Re: AOI #50 Under EPA's RCRA Corrective Action Program  
DUCO Stores – Building 34  
660 South Boulevard East, Pontiac, Oakland County, Michigan  
Facility ID No. 0-0018277  
MDEQ Confirmed Release Nos. C-0235-90, C-0776-90, and C-1831-91

## ATTACHMENT A

### MDEQ COMMENTS AND CRA'S RESPONSES

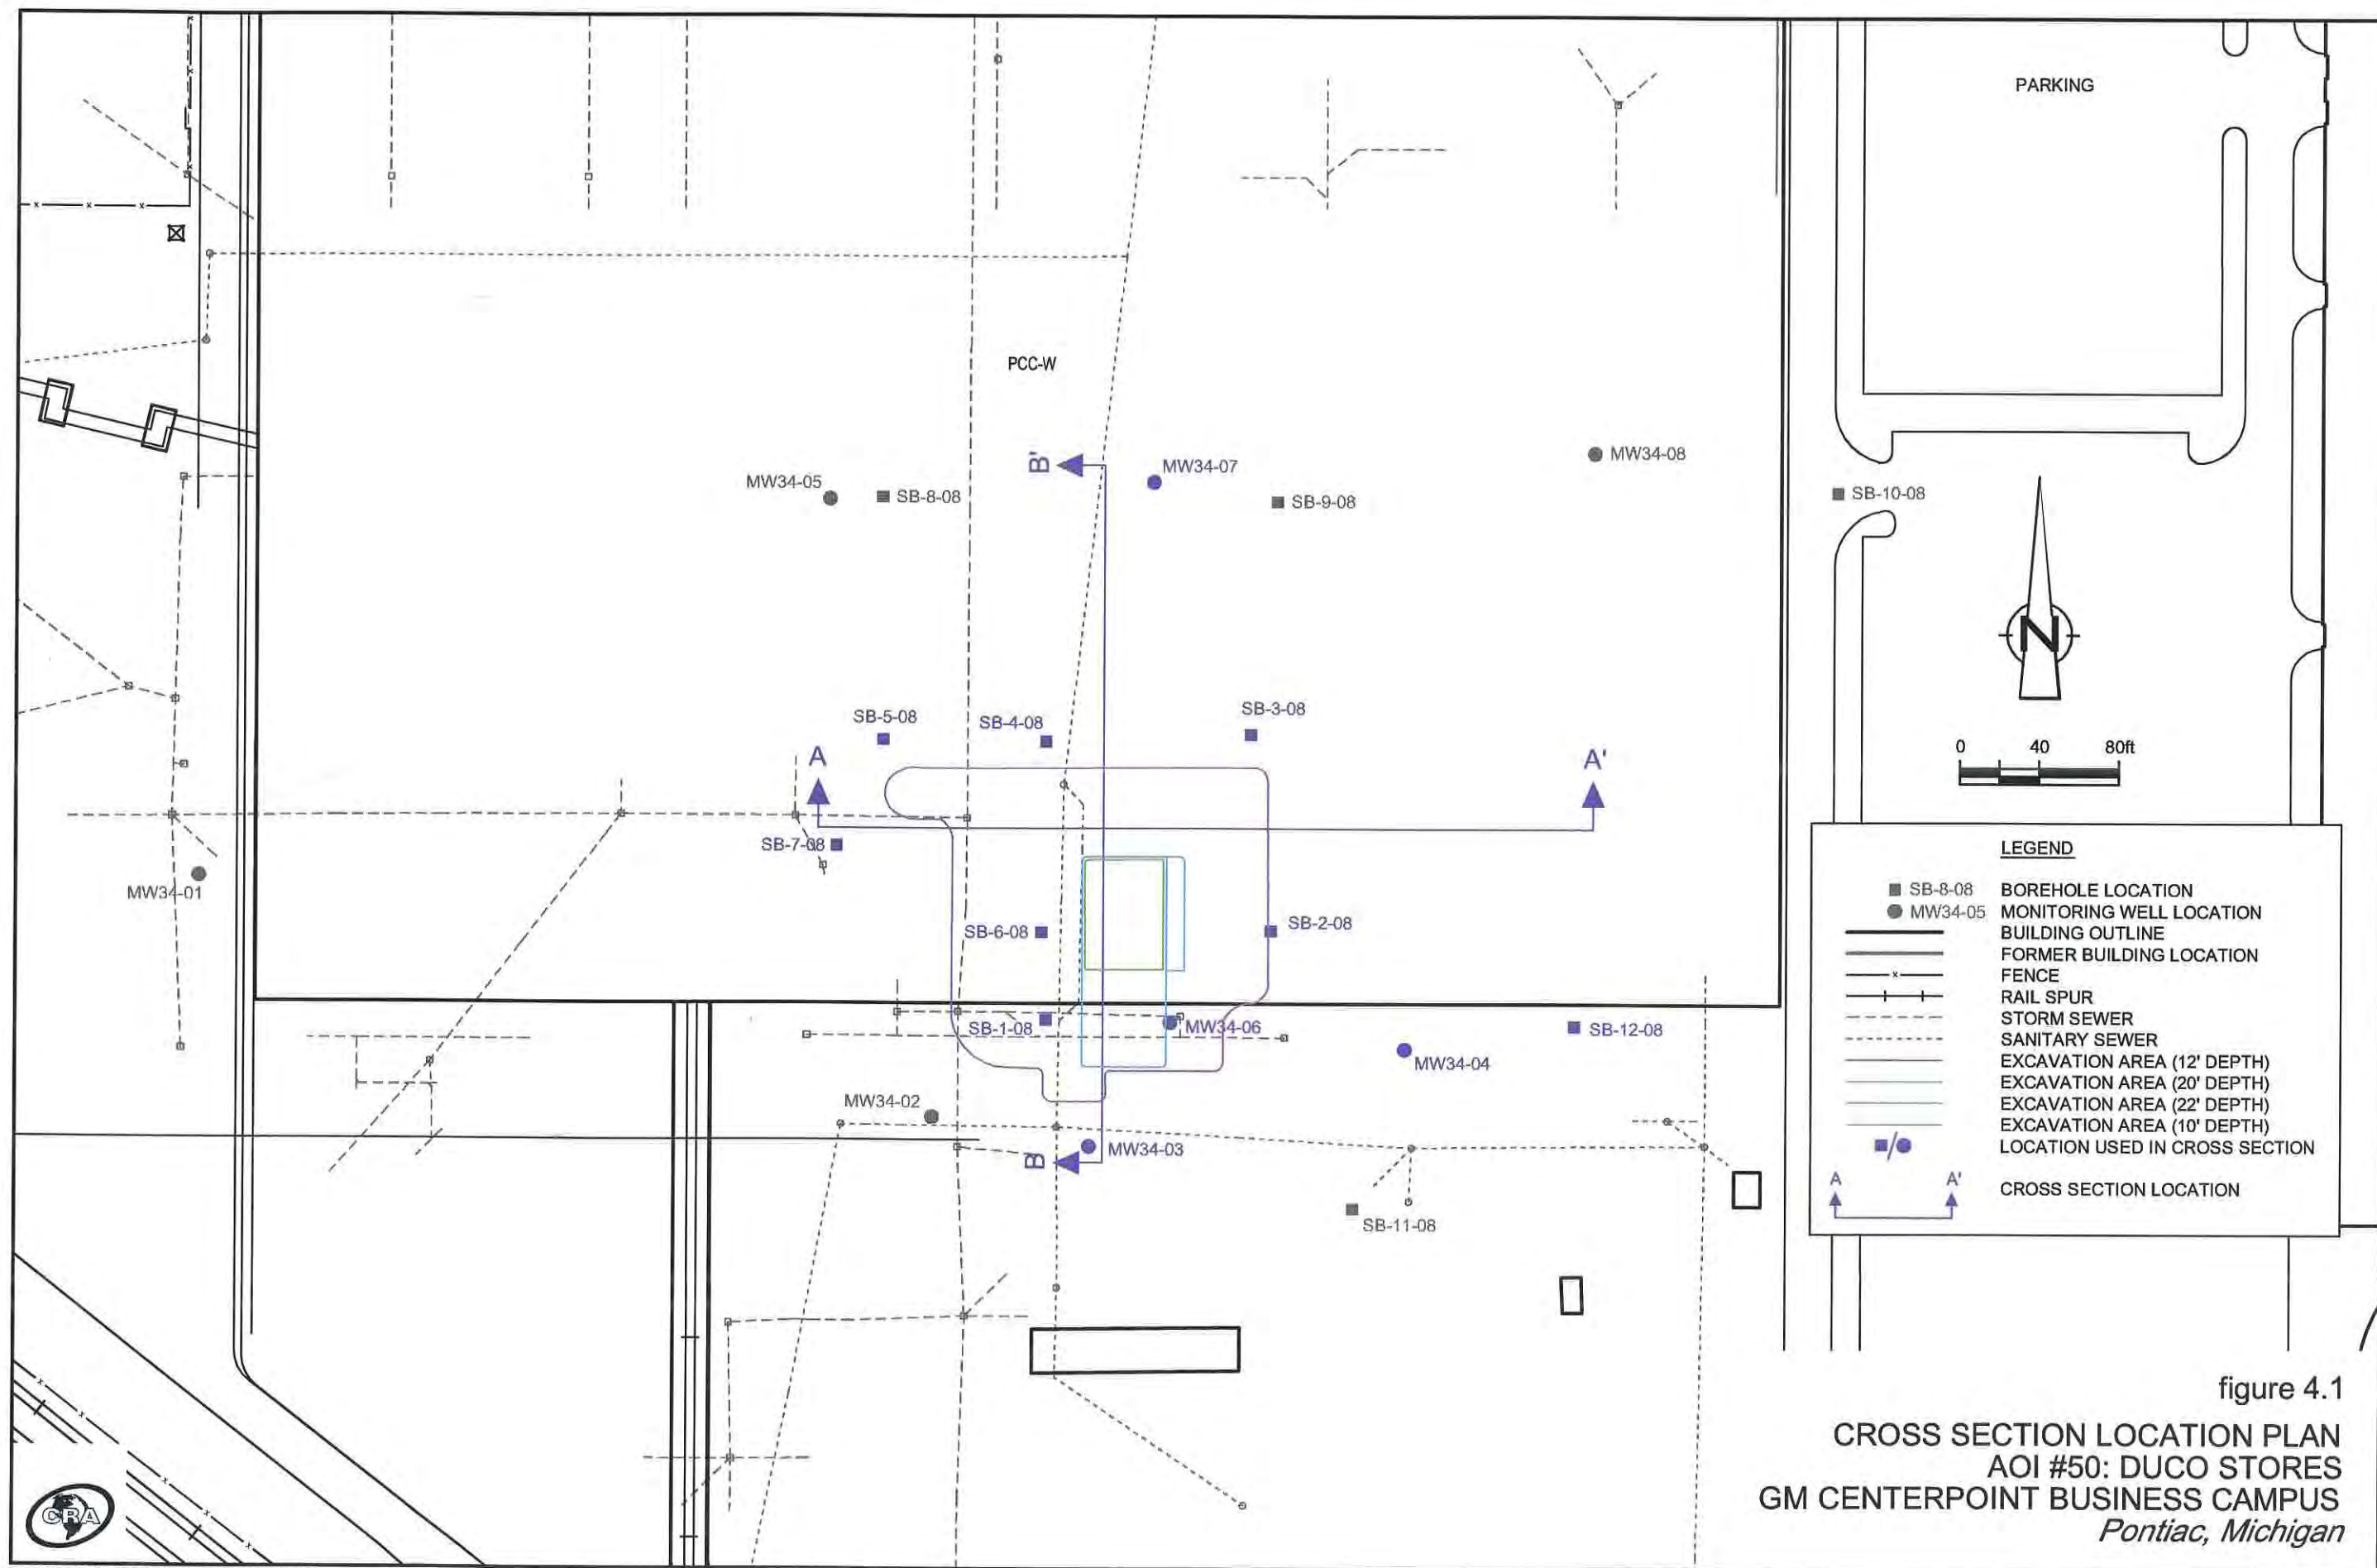
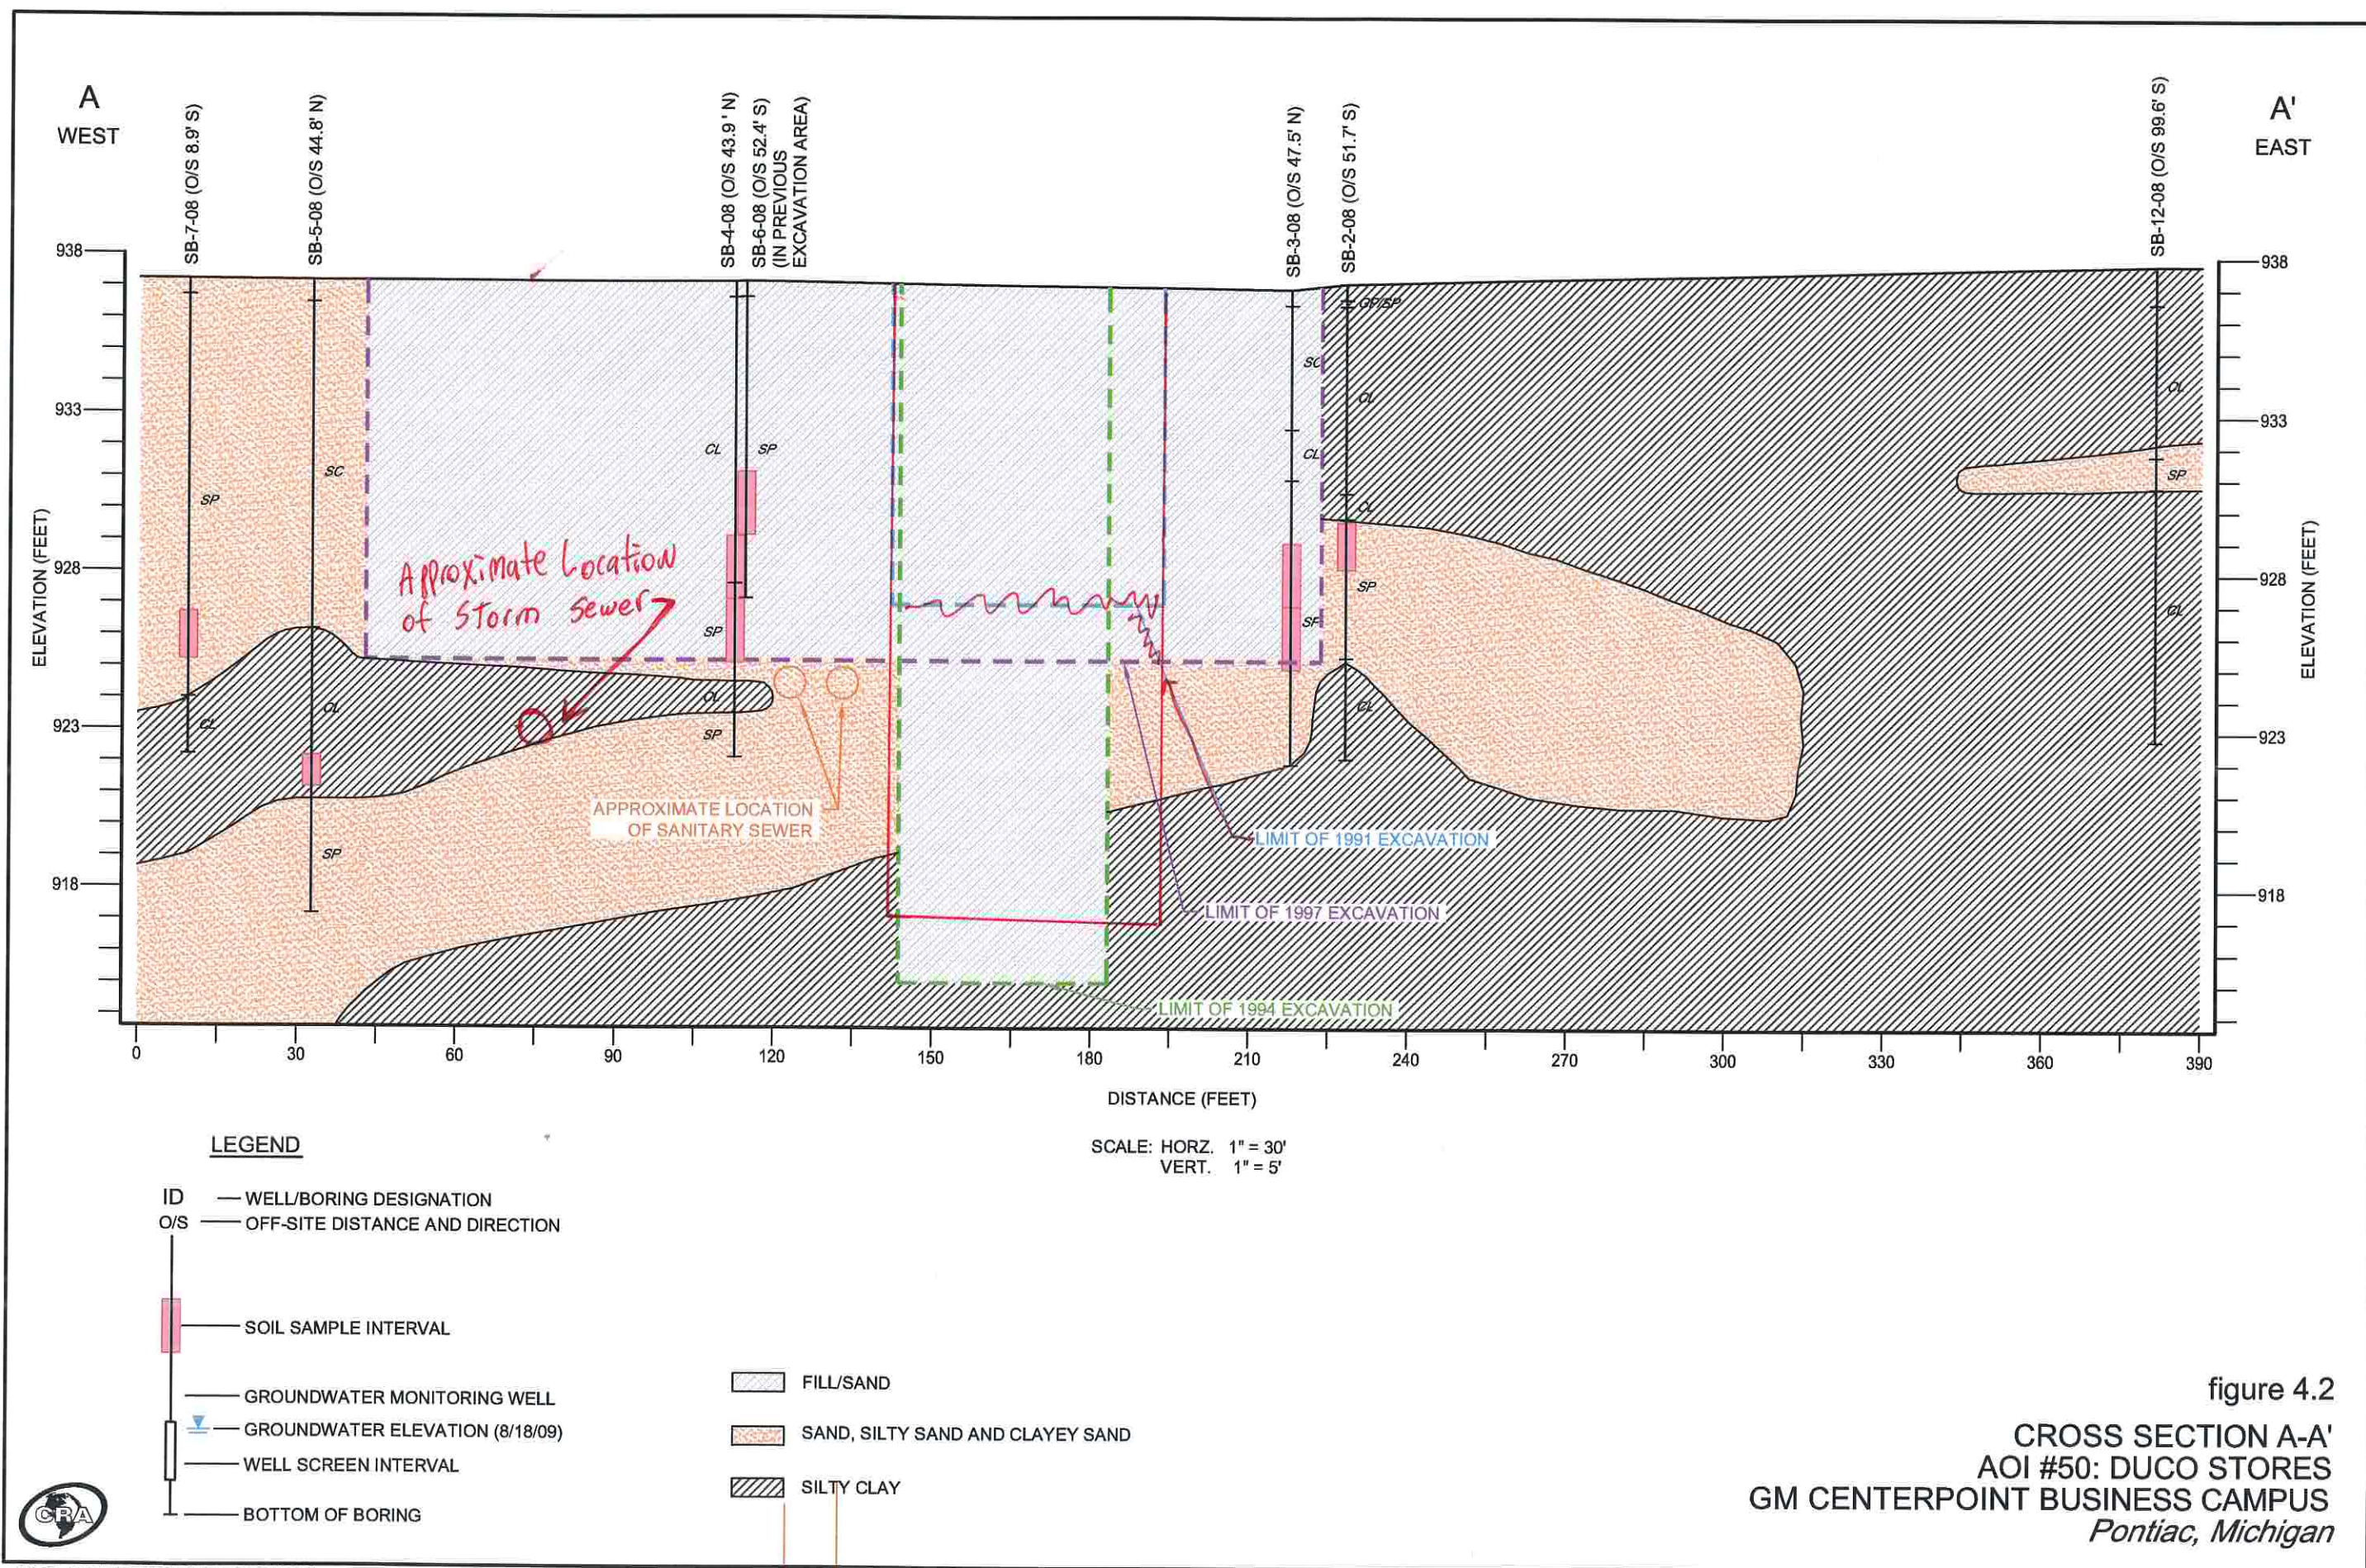
*Figures 4.1, 4.2 and 4.3 appear to be incorrect. The cross section figure only identifies the 1991 excavation as going to 10 feet. According to the text and verification sample depth, the excavation appears to have extended to a depth of 20 feet. This is not reflected in the figures. Additionally, Figure 4.2 does not display the location of the storm sewer.*

Figures 4.1, 4.2, and 4.3 with changes identified are attached.
